**TYPE III – HISTORIC REVIEW
STAFF REPORT AND RECOMMENDATION**

January 20, 2020

FILE NO.: GLUA-20-00004 and HR 20-03: Historic Review for a major public improvement within the McLoughlin Conservation District.

REQUEST: Historic Review for a major public improvement within the McLoughlin Conservation District to revitalize and redevelop D.C. Latourette Park with a nature play area, pathways, and new landscaping.

Landscaping Plan

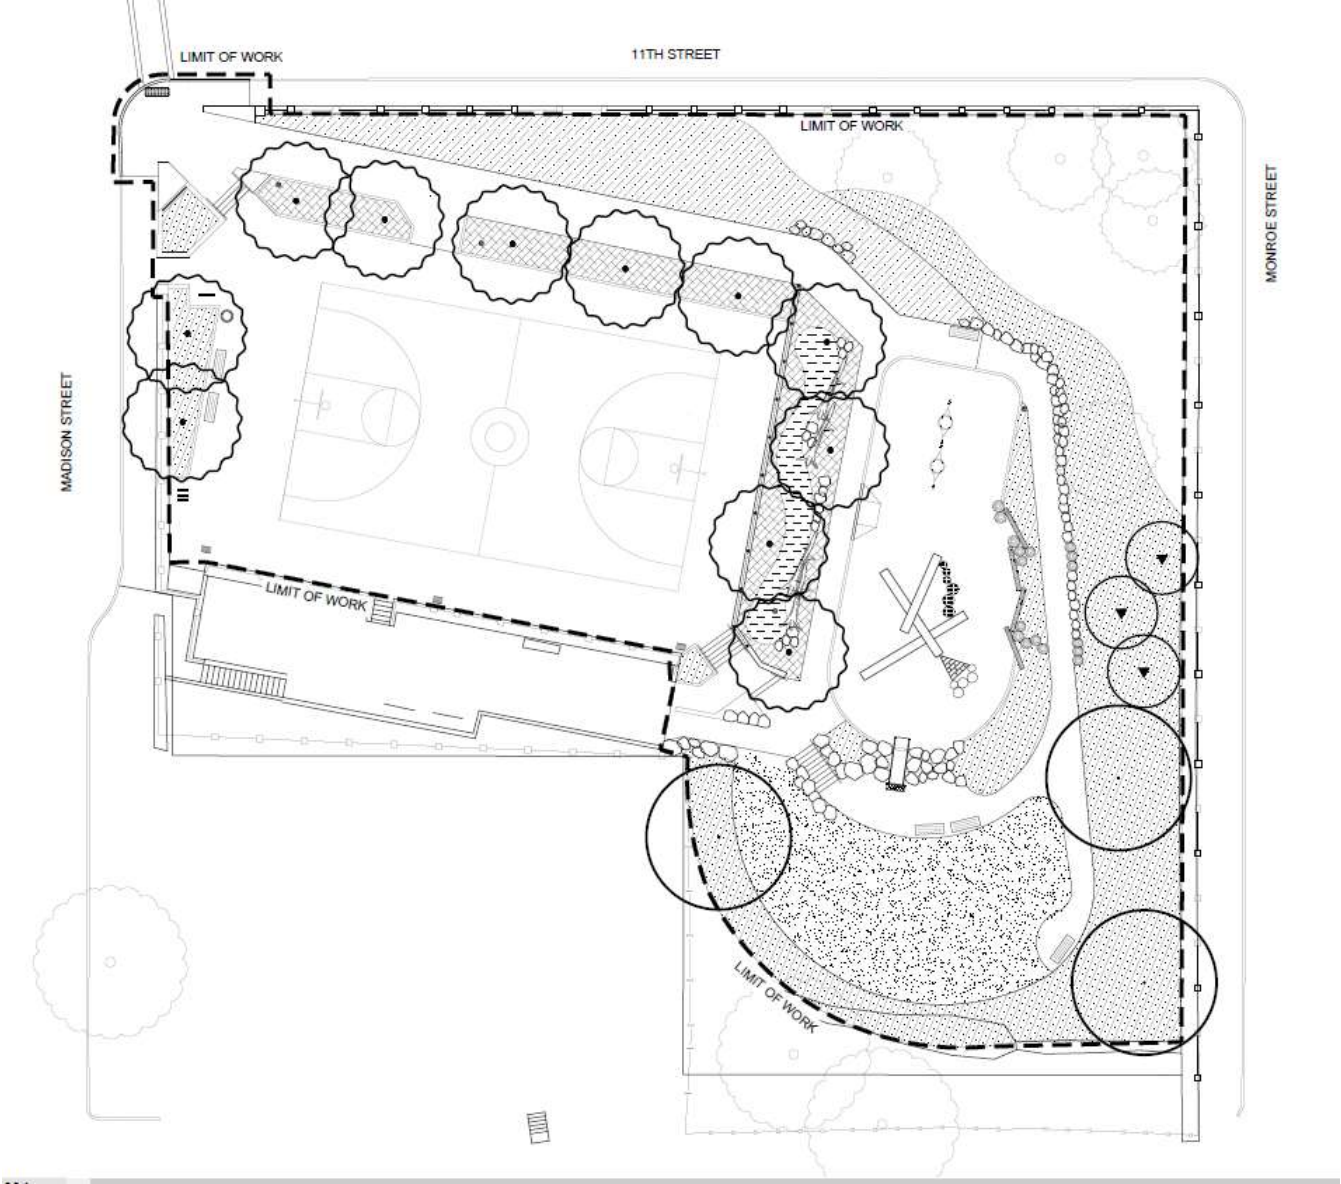
Finding: Complies as Proposed. The applicant proposes basalt and concrete walls, metal picket guardrail, and cobblestone surfacing at the corner entry. While cobblestone was found in Oregon City historically, there is no indication that it was a prevalent material. The proposed cobblestone would be used near the main entry to the park, and would be highly visible, although not a predominant surfacing material in general. The Board may want to consider how appropriate cobblestone is in this context, given that it may not have been very common in the district.

Finding: Complies with condition. The applicant proposes to use concrete, crushed rock surfacing, woodchips as playground safety surfacing, and a small amount of cobblestone paving. While cobblestone was found in Oregon City historically, there is no indication that it was a prevalent material. The proposed cobblestone would be used near the main entry to the park, and would be highly visible, although not a predominant surfacing material in general. The Board may want to consider how appropriate

The proposed bench and sign details were not provided. The applicant shall ensure that all park furnishings and signage are made of natural wood, coated metal, and do not include obvious synthetic materials, finishes, or colors.

1. The applicant shall ensure that all park furnishings and signage are made of natural wood, coated metal, and do not include obvious synthetic materials, finishes, or colors. (P)
